Sunbeam Service Sheet No. 12

Subject: Timing Chain *Tensioner fitted to Engines with S.7 Prefix*

Date: April 1952

Complete assembly No. 89-165.

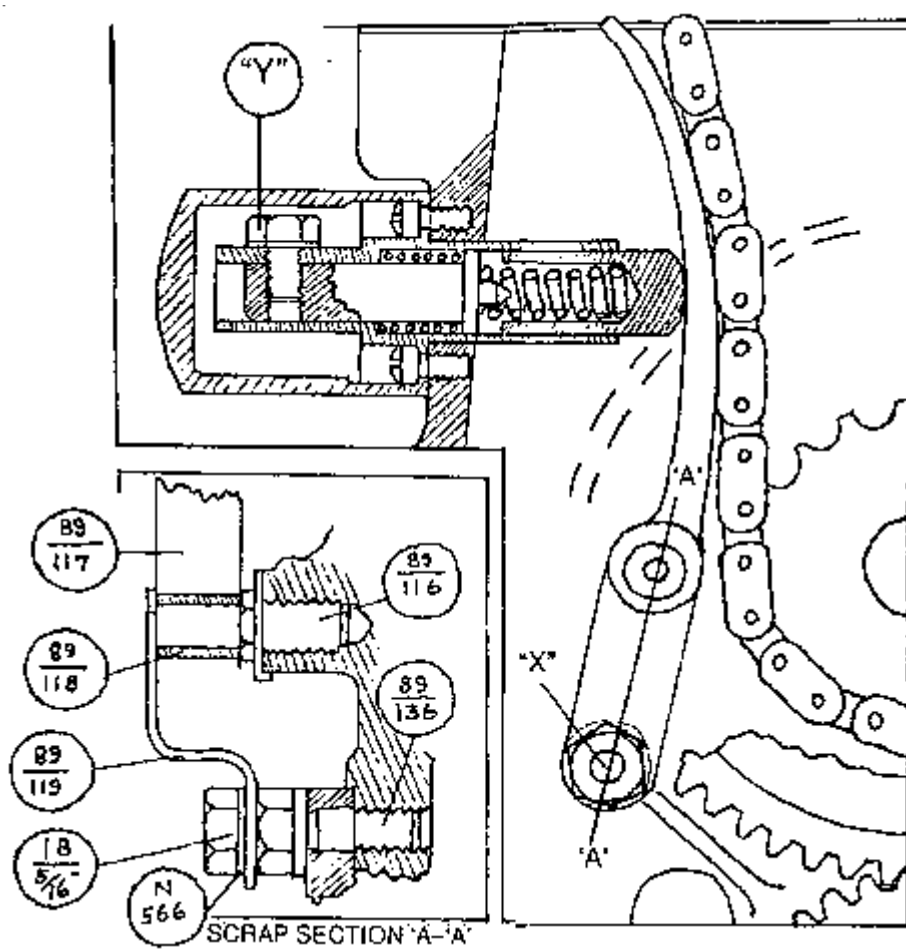
To overcome premature failure of the tensioner and spring, the complete assembly has been redesigned. The modified Chain Tensioner Conversion Set complete, Part number 89-165, can be fitted to all engines bearing the S.7 prefix. For engines bearing the S.8 prefix see Sunbeam Service Sheet No. 11.

Remove the nut and spring washer from the end cover stud immediately below the pivot pin (*marked "X" in drawing overleaf*) and extract the stud. Replace with the new stud 89-136 and replace the original nut and spring washer.

The retaining clip 89-119 can now be fitted over the end cover stud and pivot pin and secured by nut 1B - $\frac{5}{16}$ " and spring washer N 566, as shown in scrap section "AA"

Slacken off the $\frac{1}{4}$ " bolt (*marked "Y" in drawing overleaf*) and fit the assembly into the crankcase using the two screws originally removed from the inspection cover to secure it in position.
